Planning Application for rear garden deck, balustrade and screen at 28 Lyndhurst Road, London NW3 5PB

Proposed Deck & Screening to Rear Garden of 28 Lyndhurst Road, London NW3 5PB

Appendix 6
Email dated 12th
August 2016
from LBC

Photo 5 – Sample of camouflage netting for proposed screen.

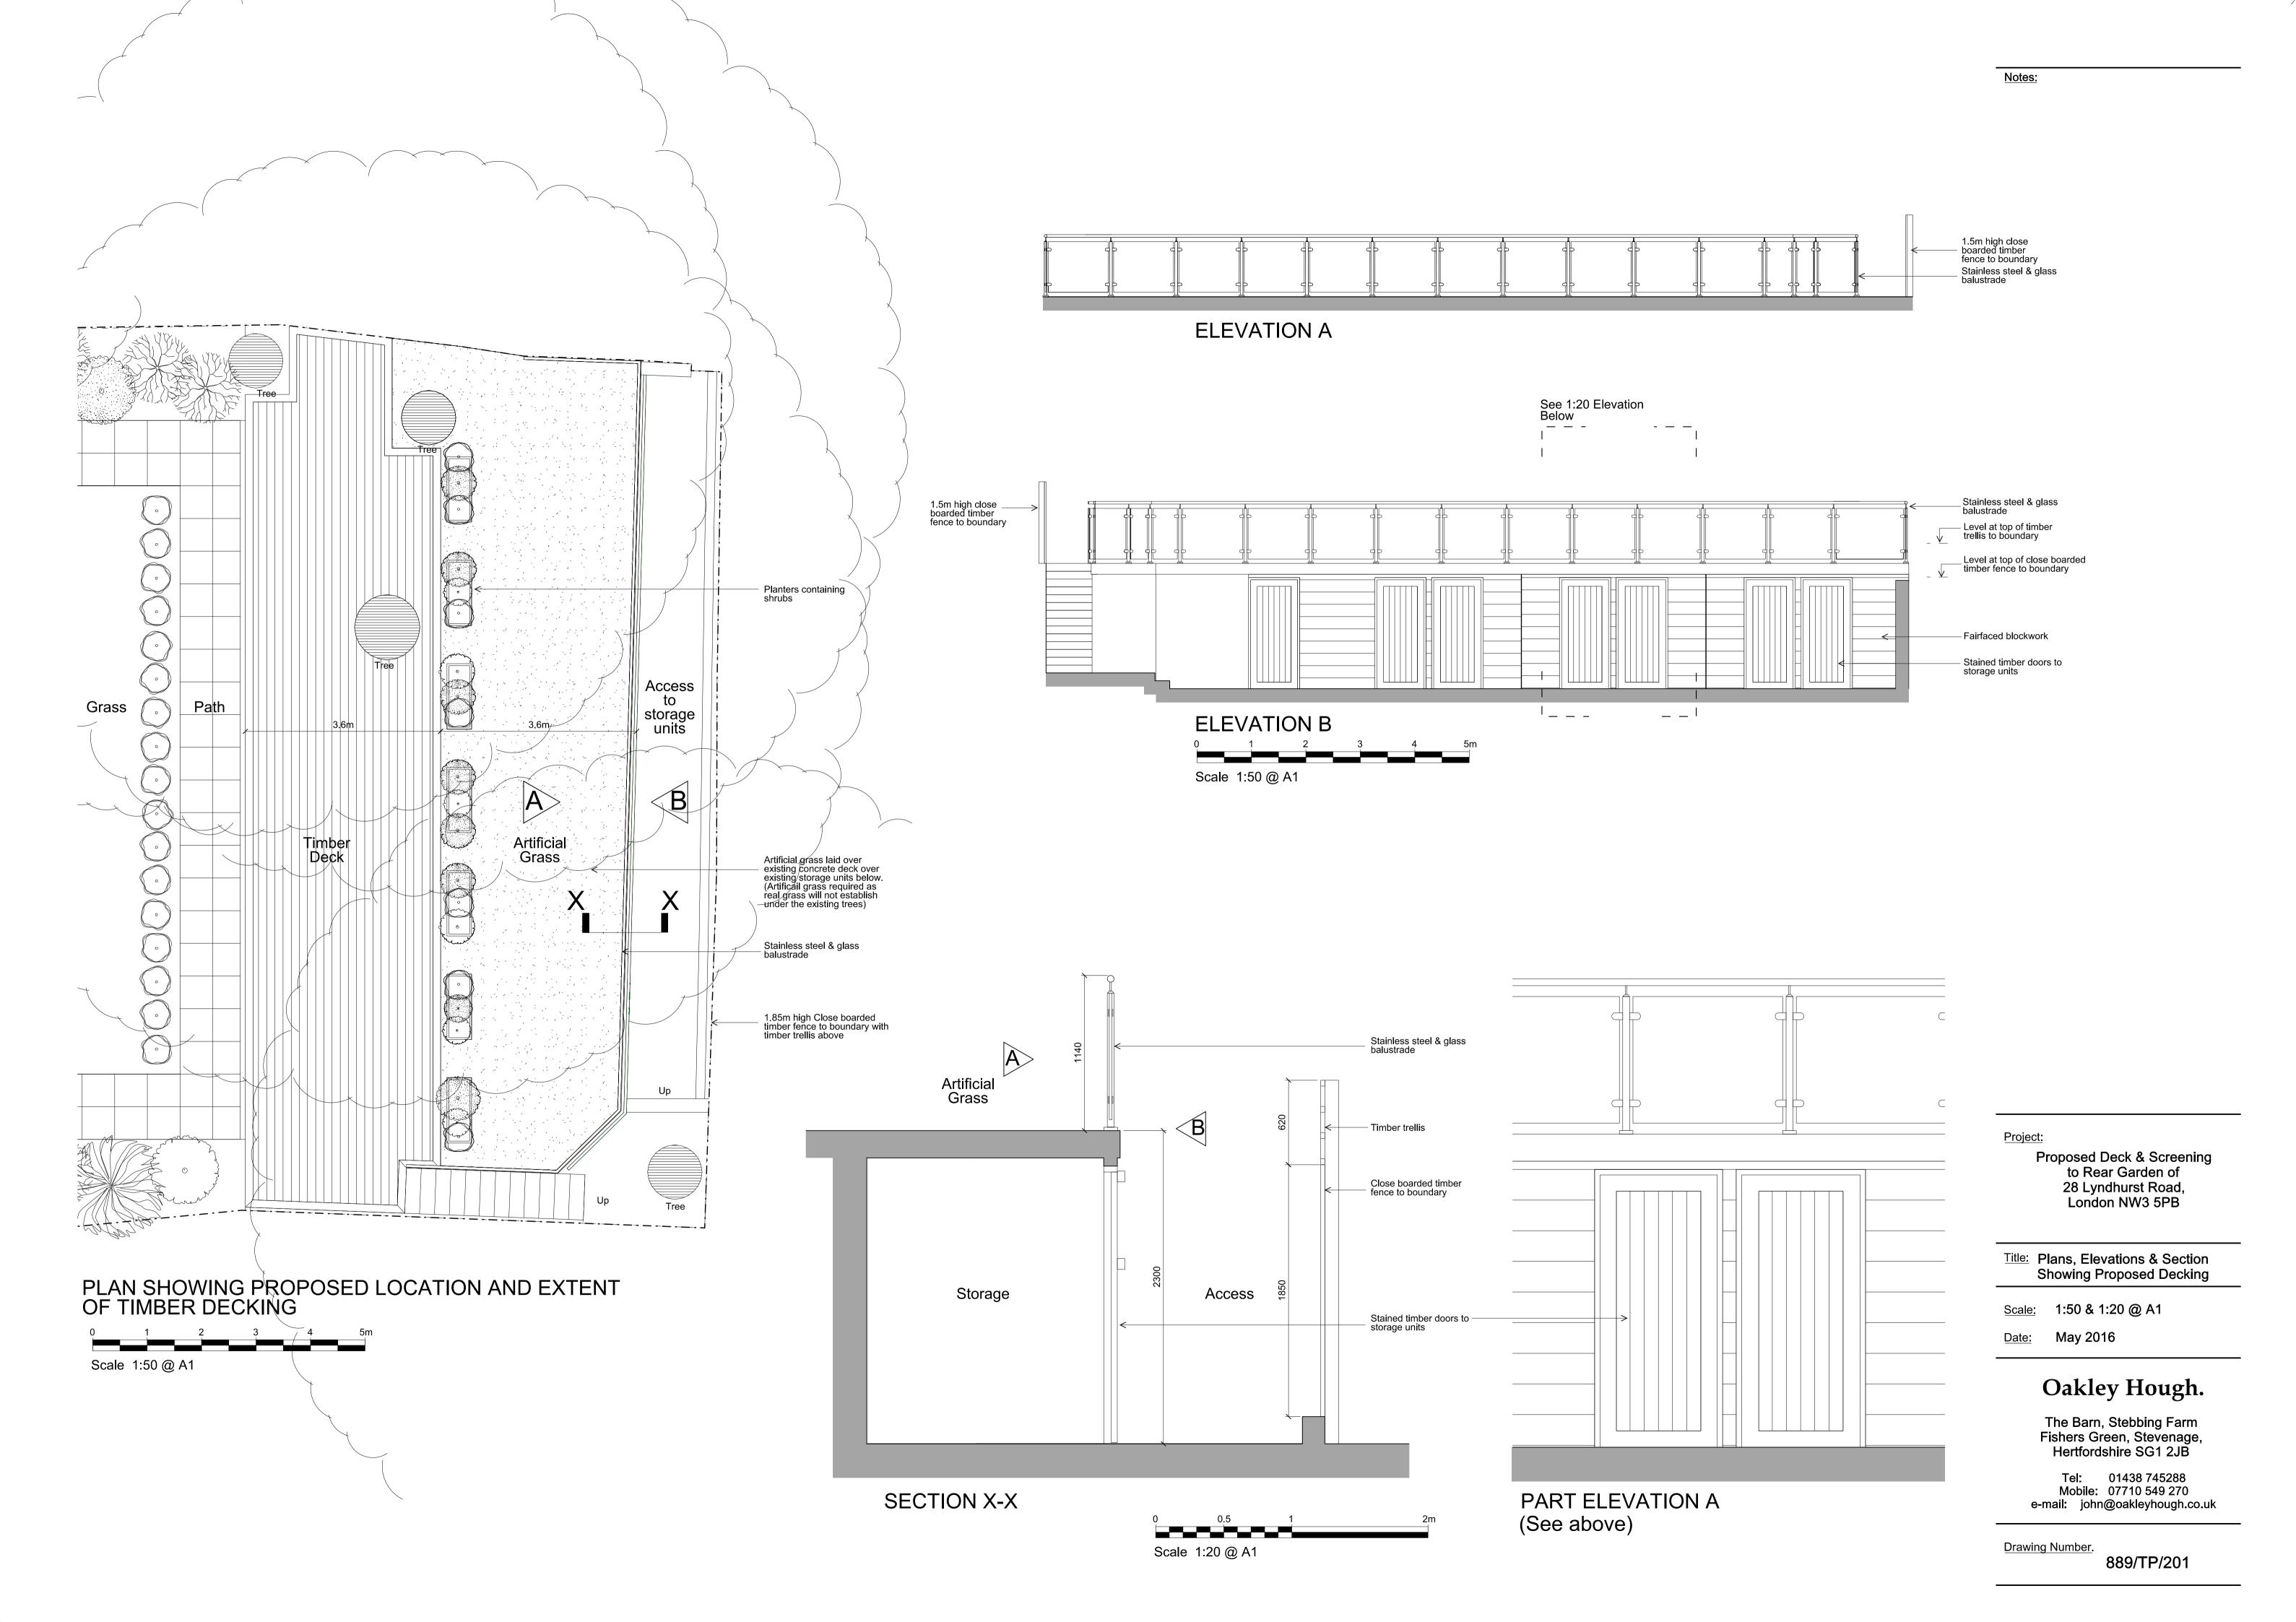
- 2. In terms of residential amenity, overlooking would occur to properties No. 27, 29 Lyndhurst Road, and to the rears of 18-22 Wedderburn Rd. I do not consider the proposed camouflage screening an acceptable solution due to its impermanent nature and unattractive appearance. The camouflage screening would not integrate with the site, appearing as a dominant addition and out of context with the surroundings. The visual impact to the adjacent neighbours with the addition of this screening would be significant and would greatly reduce the amenity that existed previously.

Note: Sample approved by Ms Angela Ryan on 12th May 2016
